# MEADOW LAKE AIRPORT

# TRANSIENT APRON RECONSTRUCTION

AIP 3-08-0063-030-2026

JUNE 2026

5 VALLEY GUTTER DETAIL (V-PAN)  
NOT TO SCALE

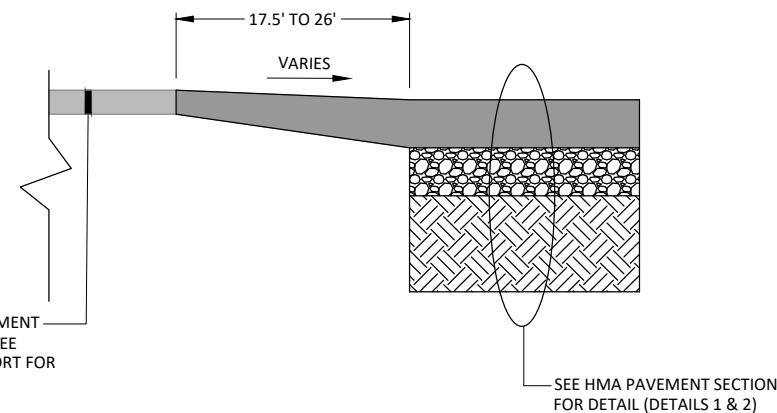
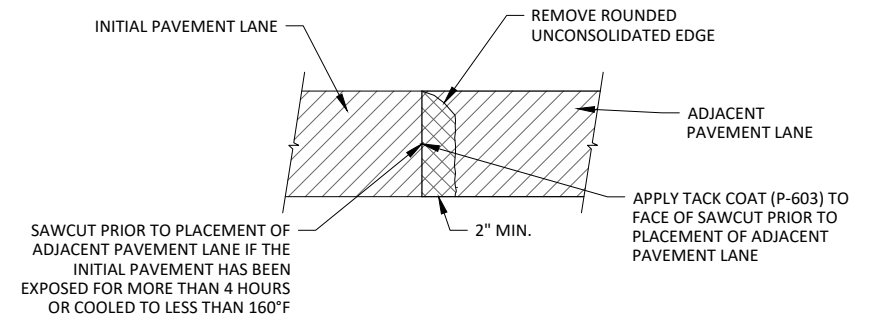
I get that the slopes coming into the pan will vary, but need to show the depth and slopes of the pan itself.

SHEET  
C2.02

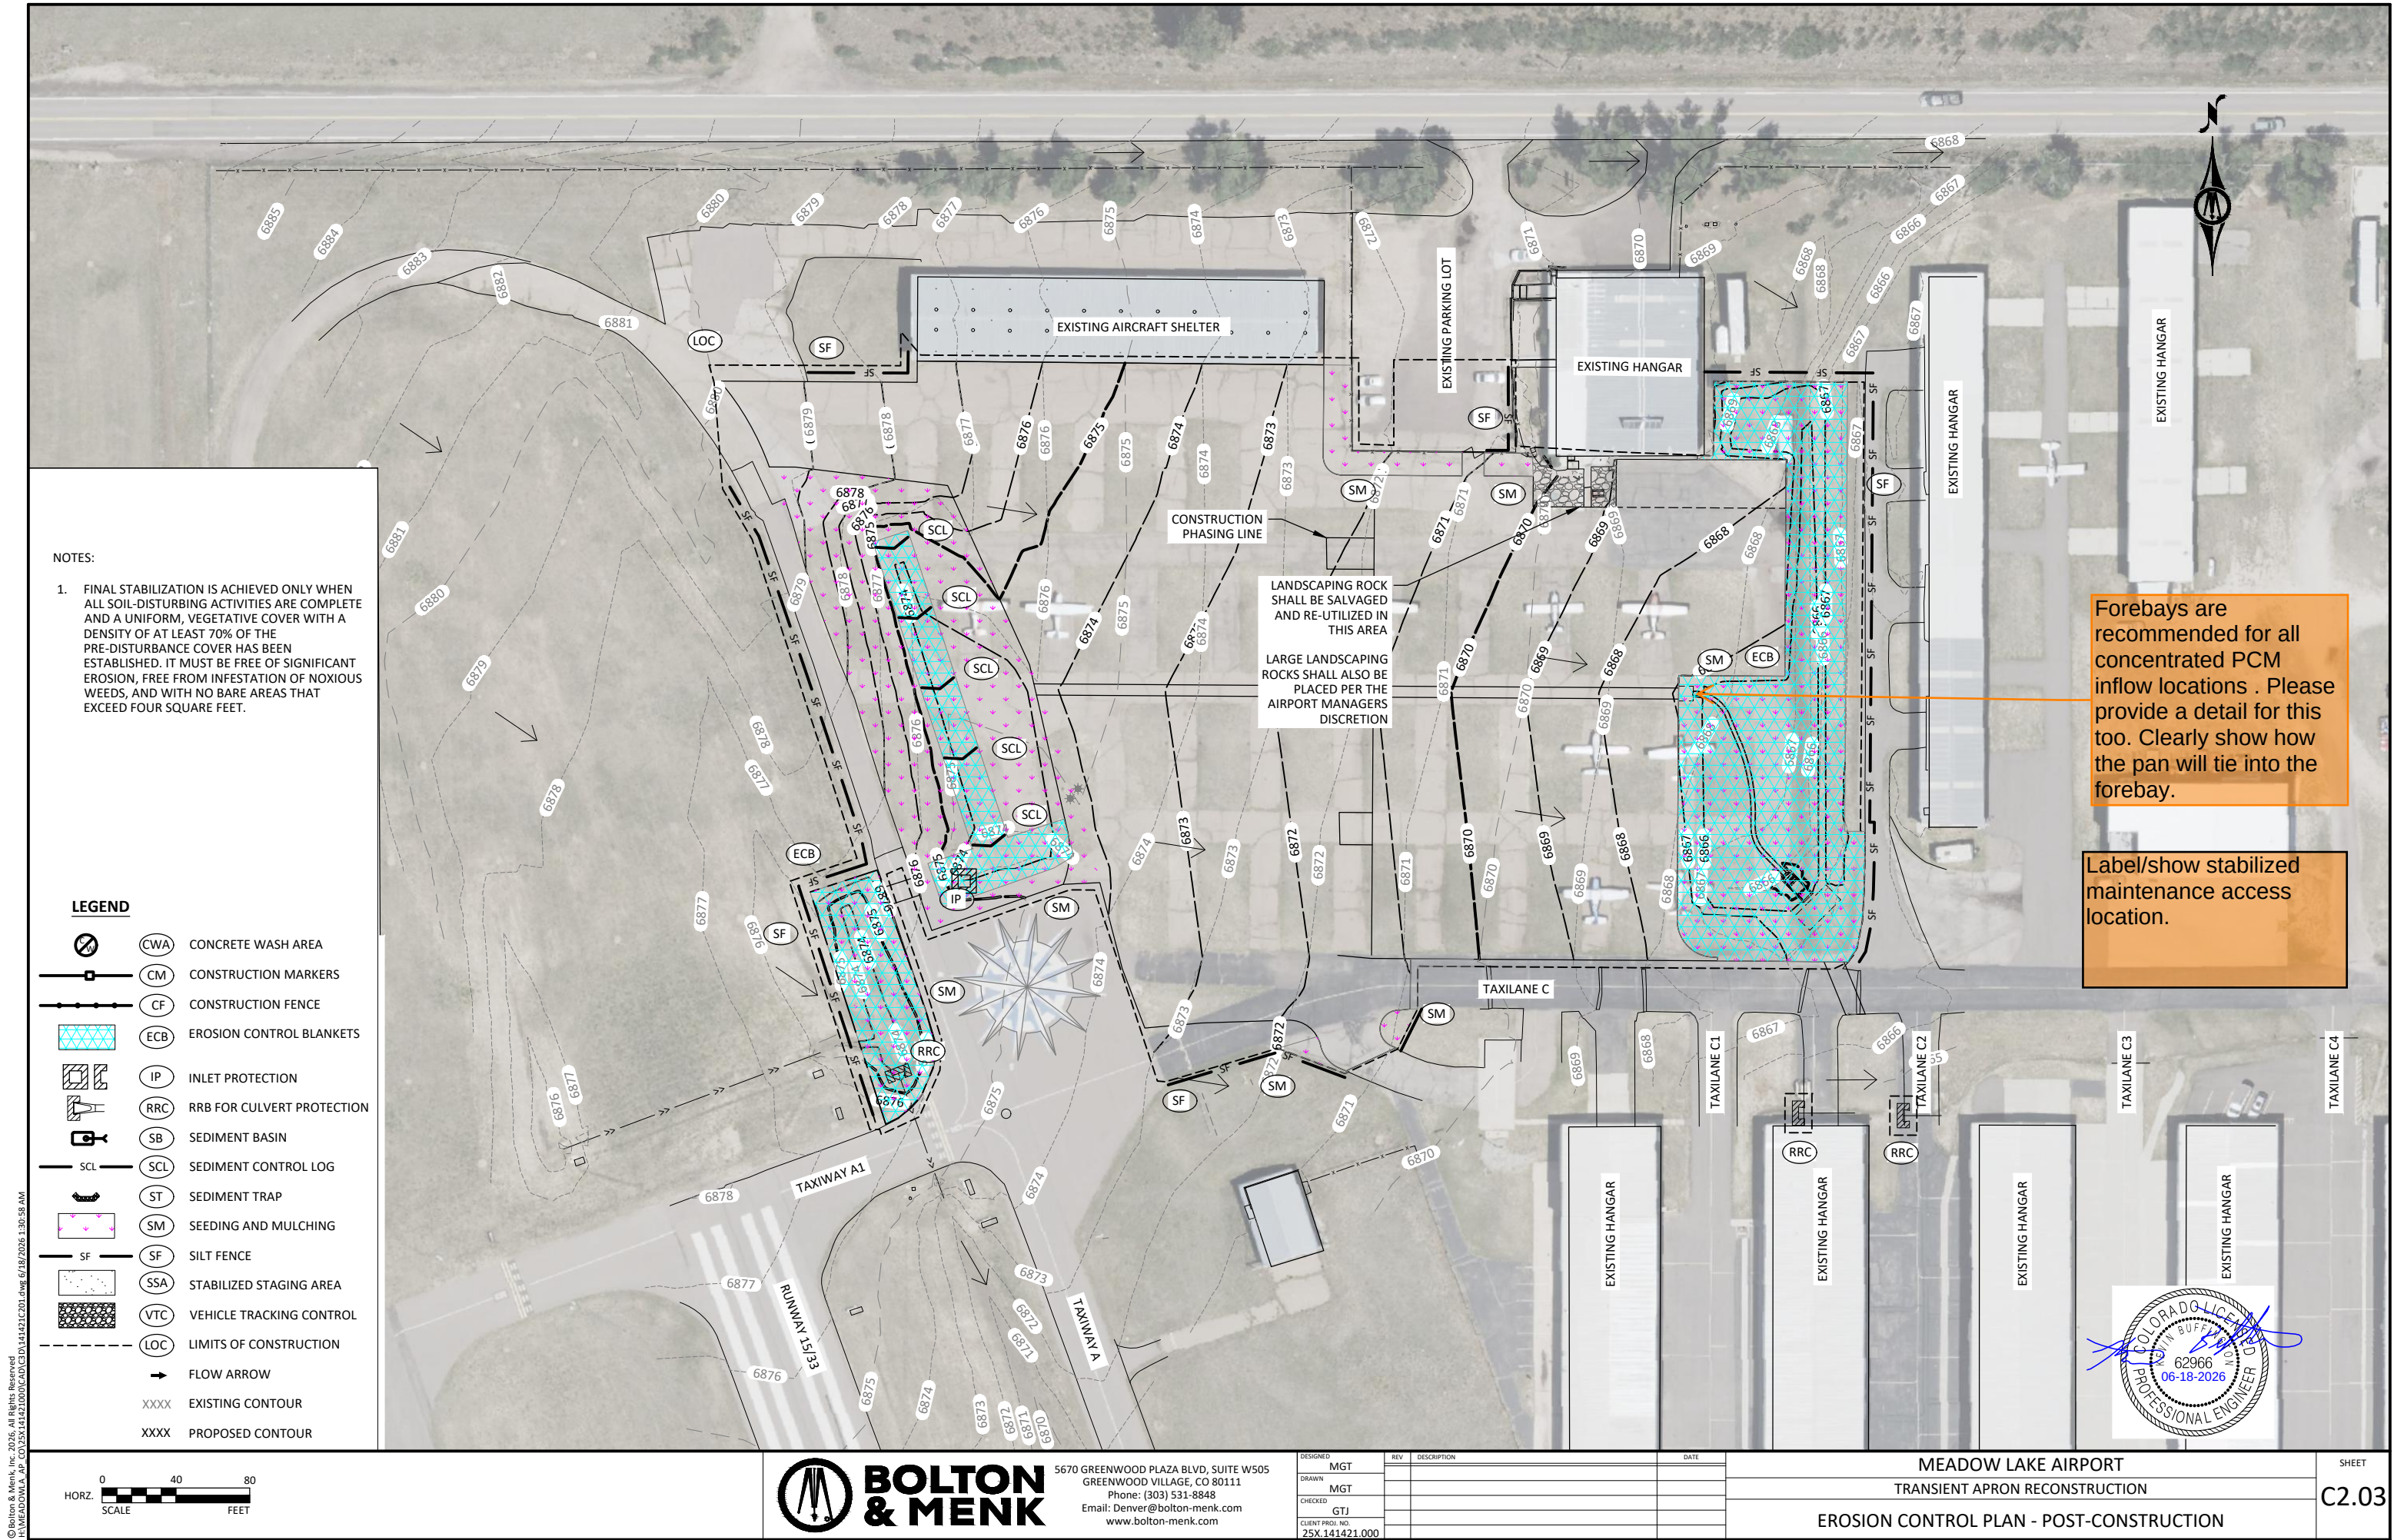
show property line

Please clarify this callout. It is pointing to a box, not a line. Preference to make the phasing line a much thicker and colorful line to really show the delineation of the phases.

Also clarify the names of the phases across all docs for consistency. Is it Phase 1 and Phase 2?

What happens here where the pan terminates at the pond? I see a box on this plan but no detail anywhere to explain what that box represents. Is it a forebay? Area inlet?

Label as a TSB on this during construction plan. You have already accounted for a TSB on the FAE Form. See my note at the bottom of this page about TSBs.

Label detention pond appropriately. See my associated comment on PDF page 9 of the FDR.

We really need a sheet that is just a zoomed in version of the pond in plan view. That is pretty standard in all CDs with a pond. You can have some pond details on the same sheet if they will fit. But we aren't getting all the pond detail we need from this scale in plan view, like callouts pointing to inflows, outlet structure, and the spillway.

show outlet pipe

For TSBs:  
Provide details of temporary sediment basin including riser pipe diameter and perforation sizing, number of rows of holes, required volume, location of outlet pipe and spillway, and tributary area to the sediment basin. And provide contours for sediment basin.

Sediment Basin (SB)

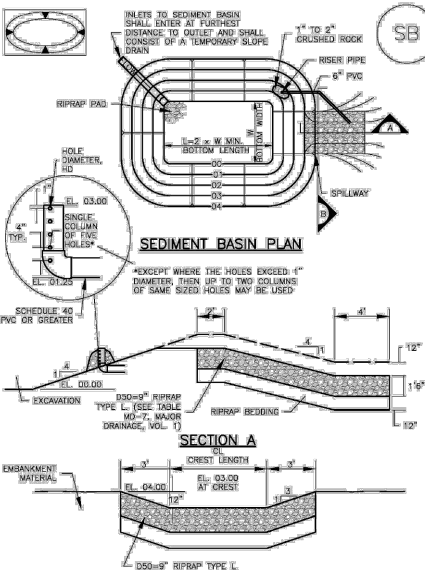
Are you intending to install a TSB? You technically need one since the proposed disturbance is >1ac, but not sure where you will daylight the outlet pipe, especially since you didn't yet show the permanent pond's outlet pipe on the plans, I don't where you plan to daylight/tie-in that. So I'll be able to comment on the TSB more with the next review.

SHEET  
C3.10

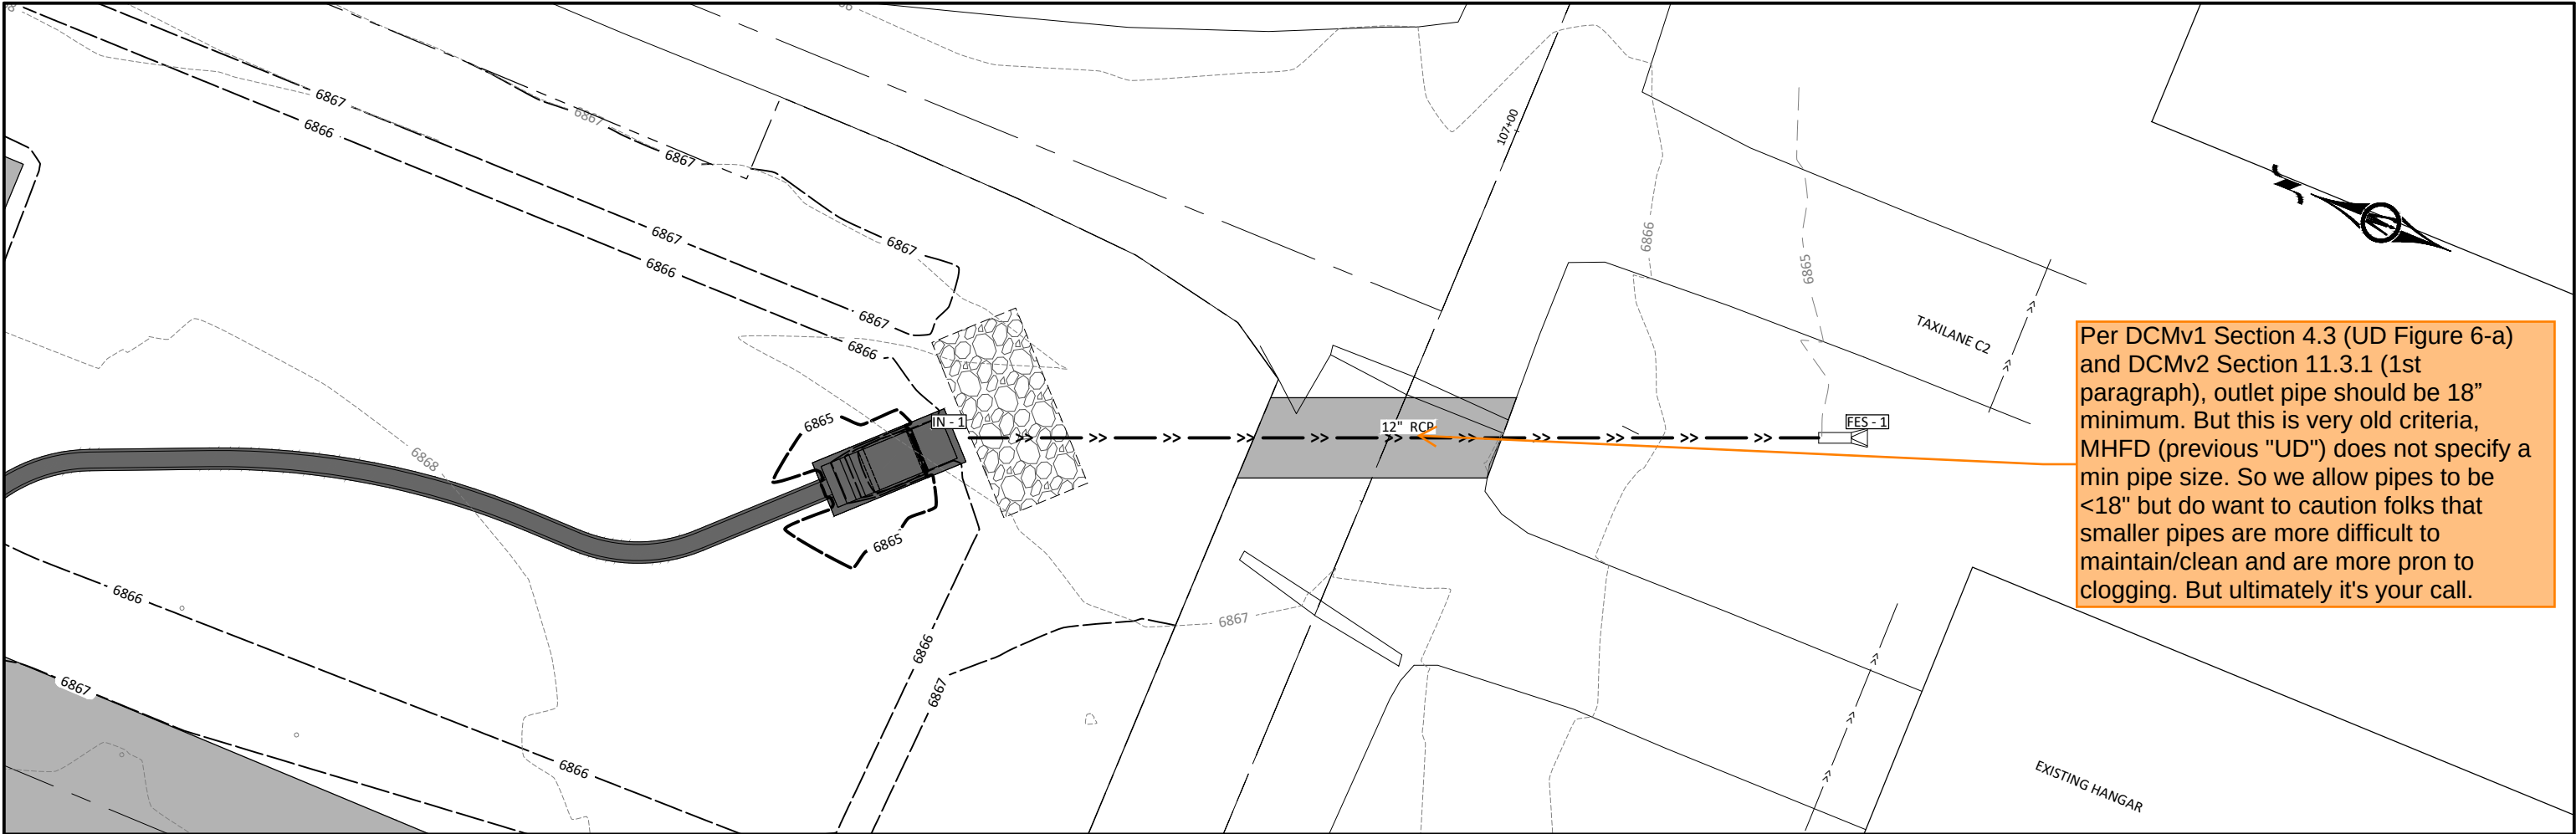
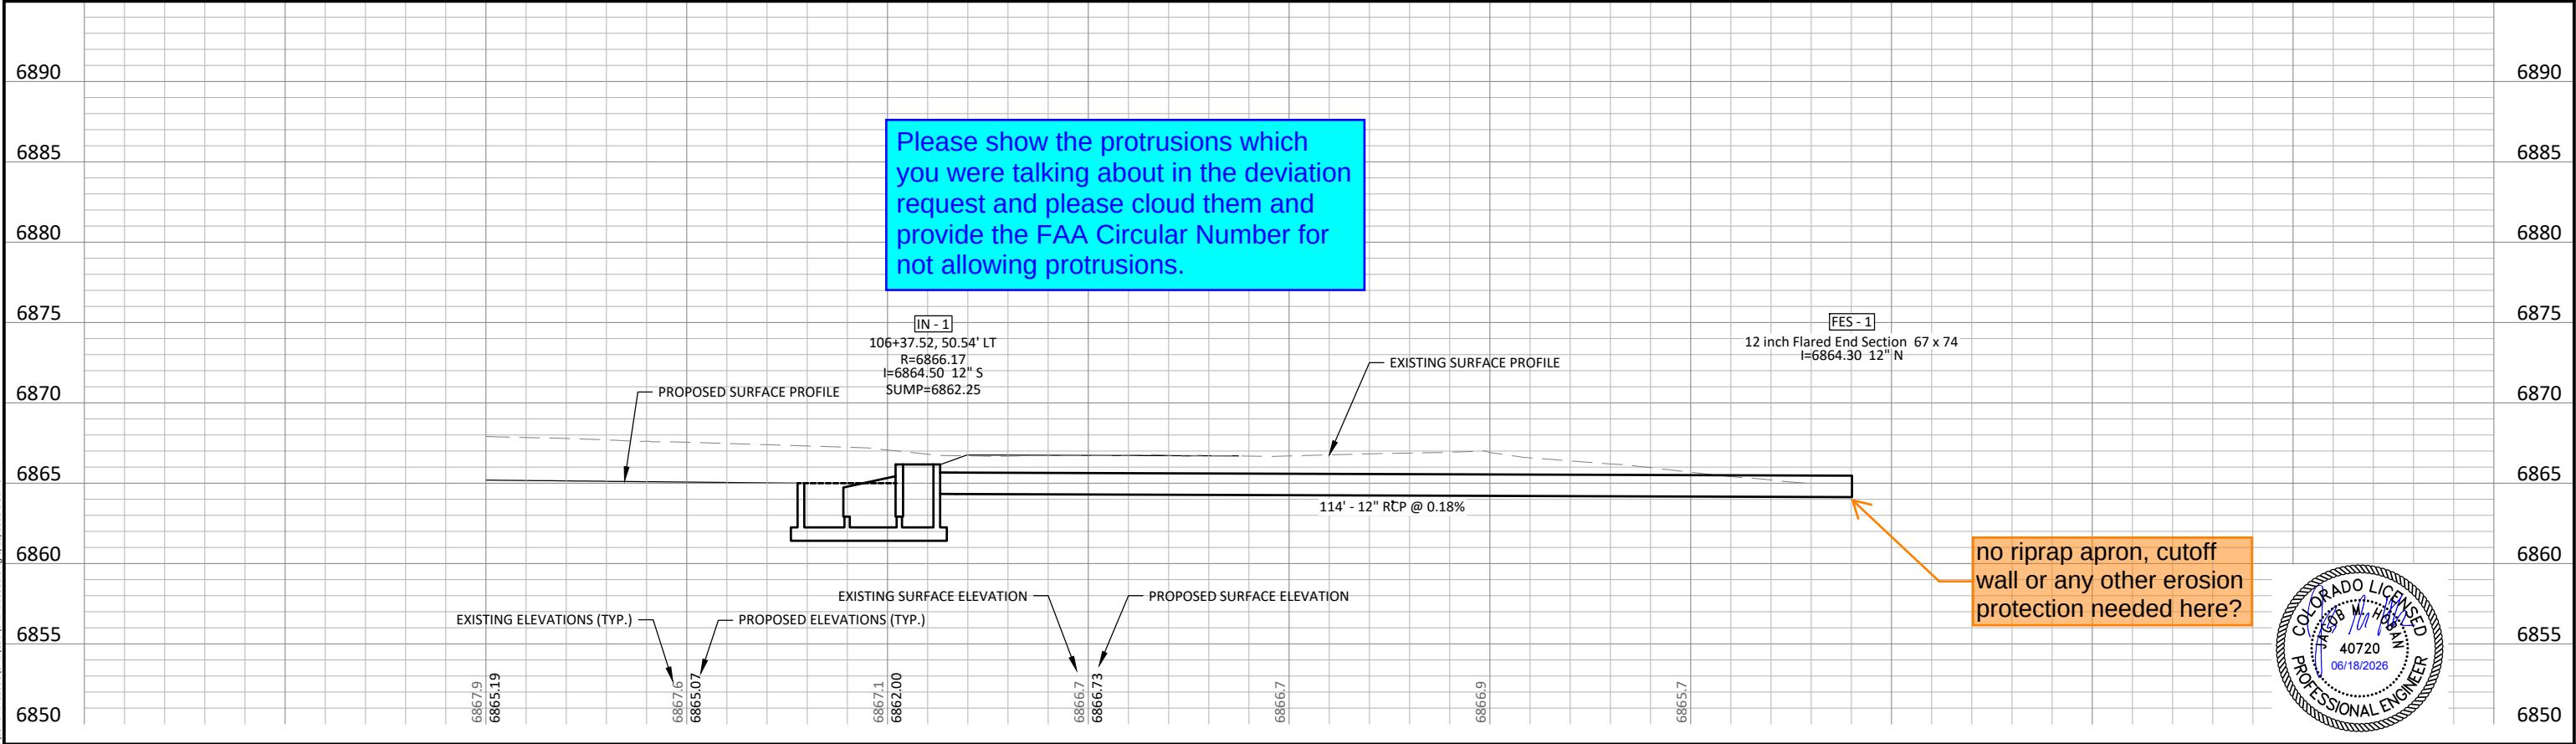
Per DCMv1 Section 4.3 (UD Figure 6-a) and DCMv2 Section 11.3.1 (1st paragraph), outlet pipe should be 18" minimum. But this is very old criteria, MHFD (previous "UD") does not specify a min pipe size. So we allow pipes to be <18" but do want to caution folks that smaller pipes are more difficult to maintain/clean and are more prone to clogging. But ultimately it's your call.

Please show the protrusions which you were talking about in the deviation request and please cloud them and provide the FAA Circular Number for not allowing protrusions.

SHEET  
C5.01

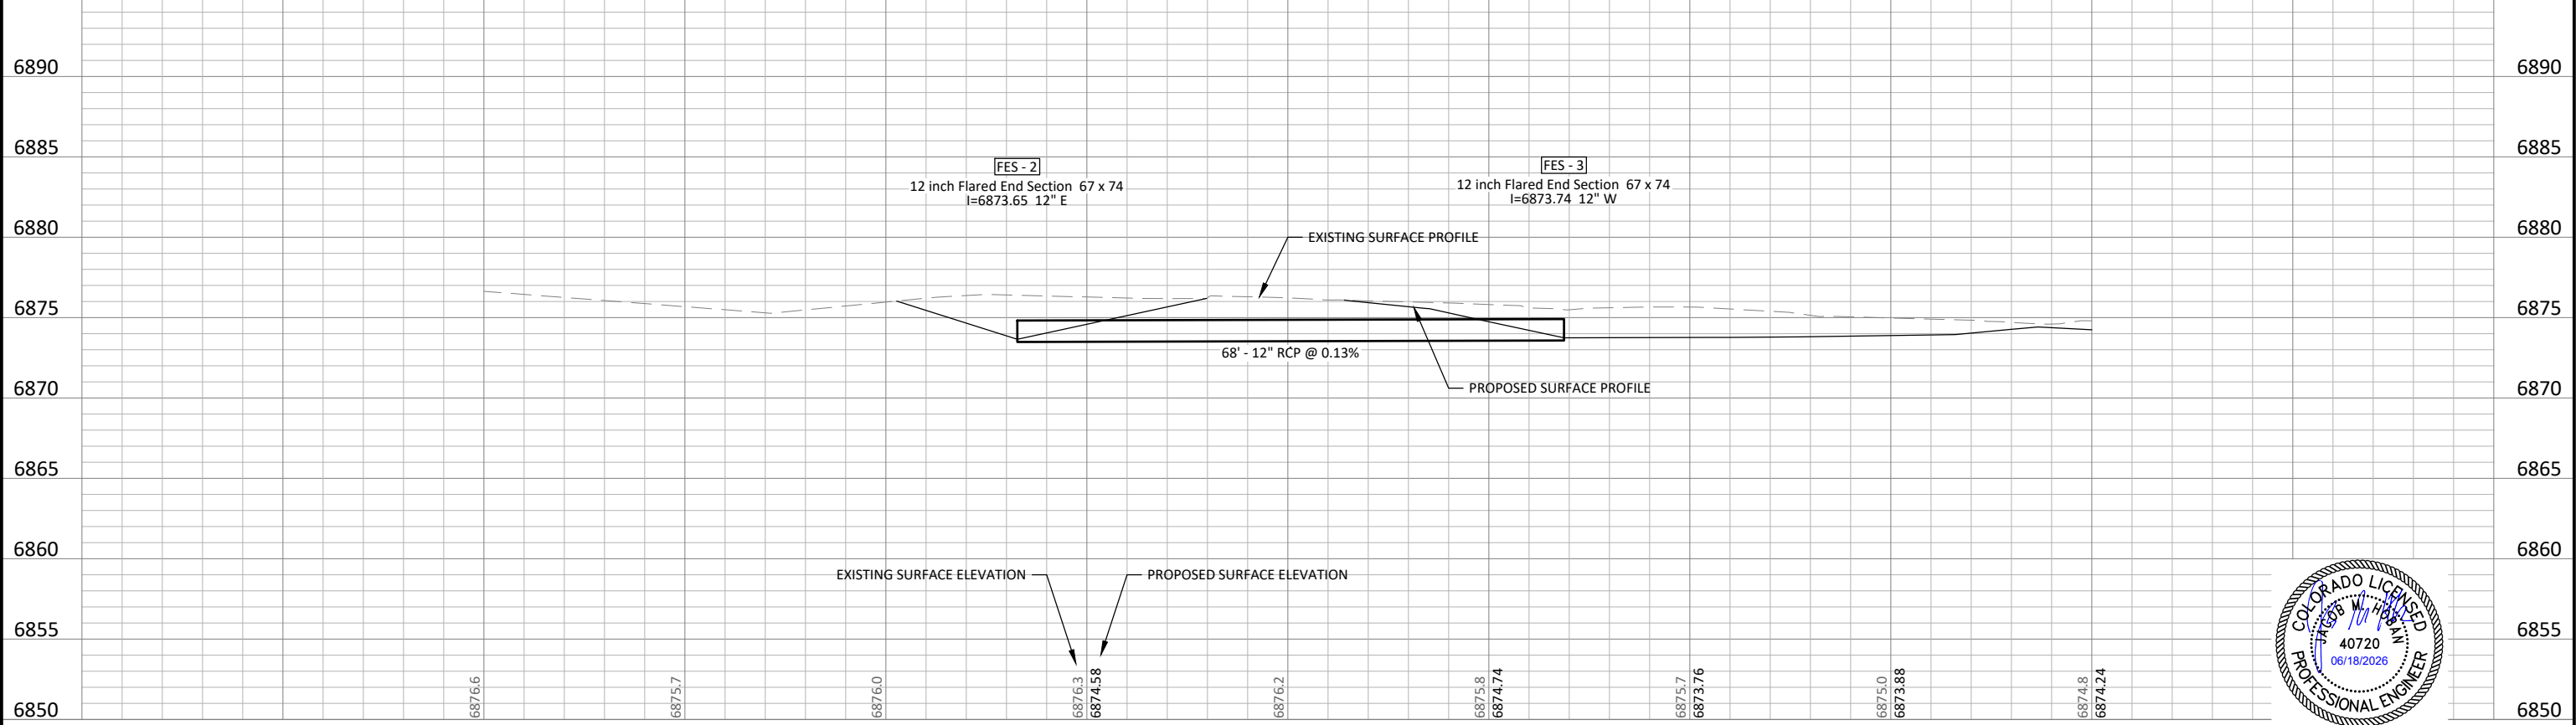
where is this pipe? Need a map key,  
a pipe name/number/label, or  
something to identify what/where this  
is.
